City of Molalla

STAFF REPORT/RECOMMENDATION TO THE MOLALLA PLANNING COMMISSION

File: M001-14-SDR, Site Design Review
Applicant: Joyce Ryan
Hearing Date: July 8, 2014 (Planning Commission)
Planning Staff: Clay Glasgow
Report Date: June 30, 2014

SITE PLAN

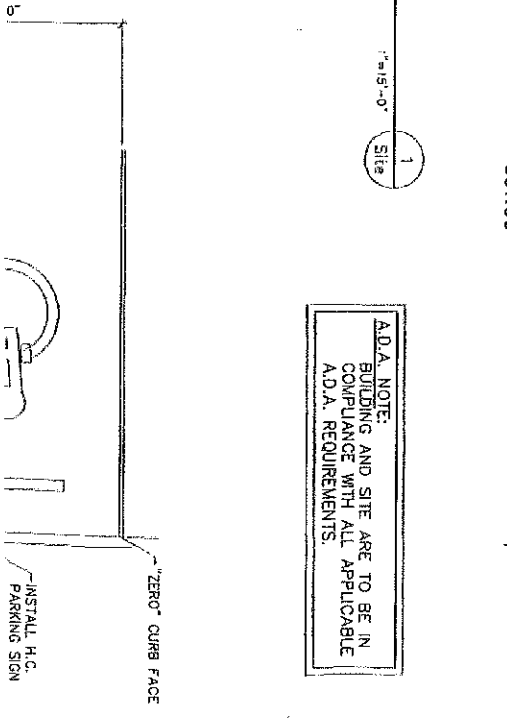
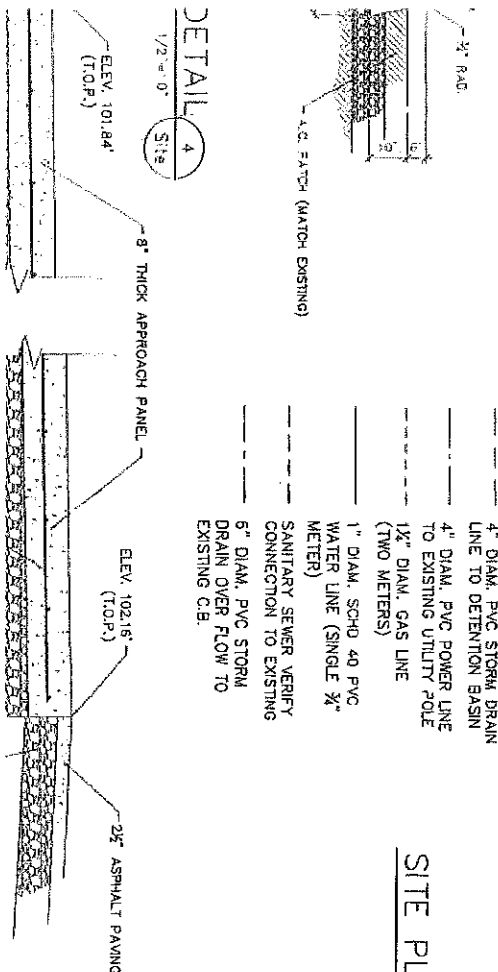
2. Title 18 of the MDC discusses Community Design Standards. Chapter 18.4 focuses on Access and Circulation. Subsection 18.04.020 deals specifically with vehicle access and circulation. The submitted site plan shows access directly onto Highway 213. Staff had questioned the city, ODOT and the applicant regarding any potential cross-over easements that may have been required as part of the Safeway development, adjacent to the south. This in an attempt to consider internal circulation via existing driveways for Safeway. No information was submitted to staff indicating such cross-over access easement is in place. As part of decision on this request a condition is warranted requiring the property owner provide cross-over easement to the property adjacent to the south, at a location approved by the city. At such time as that property redevelops, the second half of the cross-over easement will be required, a drive-aisle between the two developments constructed and direct access to/from Highway 213 for this property shall be closed. The Planning Commission should consider this during review of the application, such that current development does preclude future

shared access with property to the south. ODOT submitted written comments in response to notice of this application. Recommended conditions of approval from that Agency are included, below. As conditioned, the proposal meets requirements of this subsection.

Subsection 18.08 discusses Landscaping, Street Trees, Fences and Walls. Subsection 18.08.020 deals with landscape conservation. The landscape plan submitted to the city is lacking in detail relative to species and site percentage.

Subsection 18.08.030 details criteria for landscaping. Minimum required landscape area in the C-2 zone is 15%. It would appear this percentage is met, though no calculations are provided. The submitted landscape plan does not provide enough detail on this or other required features. Also, a minimum of five (5) street trees will be required. Other applicable criteria from this subsection are discussed in the application materials. The Planning Commission should consider landscaping, and at a minimum include a condition of approval requiring submission of accurate, complete landscape plan. As conditioned the proposal could meet applicable criteria.

Section 18.12.030 details automobile parking standards. Submitted site plans show detail for parking. This type of use requires a minimum of eight (8) parking spaces per thousand square feet of floor area. A total of 16 on-site parking spaces are shown. With building area of approximately 2,000 square feet this meets the minimum number of parking spaces. At least two of the spaces in the southwest portion of the parking area could be problematic as far as maneuverability. A condition of approval should be added that applicant submit detailed parking plan.

7. The applicant shall submit a letter to the city from the franchise hauler indicating approval of a plan for trash/recycling storage and collection.
8. The applicant shall submit detail for on-site parking, to include striping for a minimum of 16 parking spaces. This plan to be submitted to staff and approved prior to occupancy.

9. Prior to site development the applicant shall submit a complete landscape plan, addressing all required elements.
10. The proposed landscaping shall be installed prior to occupancy and shall be continuously maintained. Landscape maintenance shall be the responsibility of the owner.

14. Installation of curbs and sidewalks, if necessary, shall be constructed to city standards.
15. Property owner to provide cross-over access easement to property to the south (Safeway) at a location approved by the city. When the property to the south re-develops, reciprocal cross-over easement to be granted to subject property. Driveway to be constructed at that time to provide for internal circulation between the two properties.

16. At such time as cross-over easements are effected and internal driveway constructed, driveway at 213 will be abandoned and removed.
17. Construction of storm drainage improvements associated with the development shall be consistent with city standards. Storm water detention area to meet or exceed NPDES regulations and be reviewed by the City engineer. Compliance with the drainage requirements of the plumbing code administered by Clackamas County.

FRONT ELEVATION

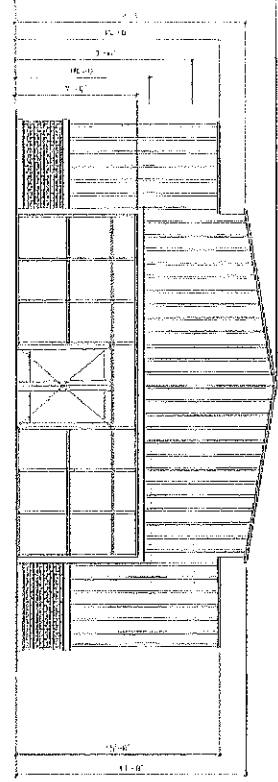
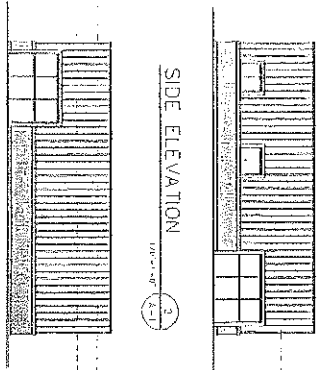
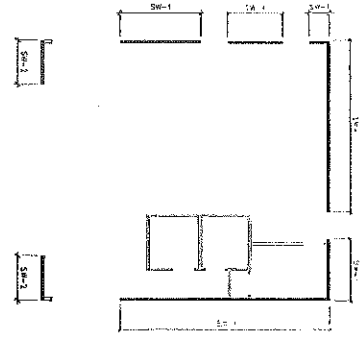
Subsection 17.12.060-070 discuss building height and architectural design standards. Submitted plans show a structure that appears almost barn-like. The Planning Commission should discuss the building, as well as site design.
